TECHNICAL MEMORANDUM

Review of DRAFT: Investigation of Ground Water Contamination near Pavillion Wyoming

Prepared by the Environmental Protection Agency, Ada OK

Prepared by: Tom Myers, Ph.D.

Figure 1: Snapshot from EPA (2011) Figure 3 showing frequency of depth for gas wells (top), surface casing for gas wells, and base of domestic wells.

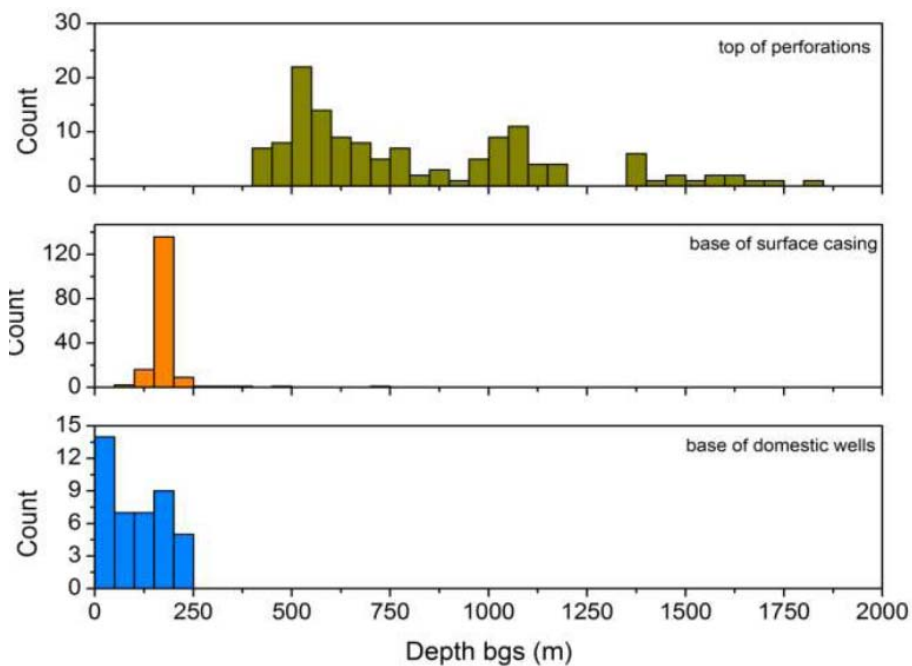
EPA established two dedicated monitoring wells to supplement the data obtained from the water wells. The new monitoring wells were primarily screened below the level of the water wells (Figure 1) and above the gas production wells to “differentiate potential deep (e.g., gas production related) versus shallow (e.g., pits) sources of groundwater contamination” (EPA p 5). The EPA established just two monitoring wells due to a limited budget (Id.). EPA placed the monitoring wells’ screened interval along the conceptualized vertical pathway between the potential contaminant source (i.e. the production wells and/or zone) and the water wells. The monitoring wells were designed appropriately to detect and monitor contaminant movement upward from the production zone to the water wells; if the monitoring wells had been constructed at the same depth as the water wells, they would not have added substantial useful information.

Figure 1 (EPA Figure 3) shows that domestic water wells in the regions are screened at all levels down to about 250 m, or more than 800 feet, with half of the wells being deeper than 300 feet, similar to the depths found by Daddow (1996) in other areas of the aquifer. However, the EPA states the information source was from the State Engineer *and* homeowner interviews (EPA p 2). It is unclear whether both were used for each well. It is my experience that homeowners have a poor concept of the depth of their well unless they have paperwork that documents it.

Recommendation: The EPA should provide more information about the source of its water well construction data, showing it in EPA Table A1.
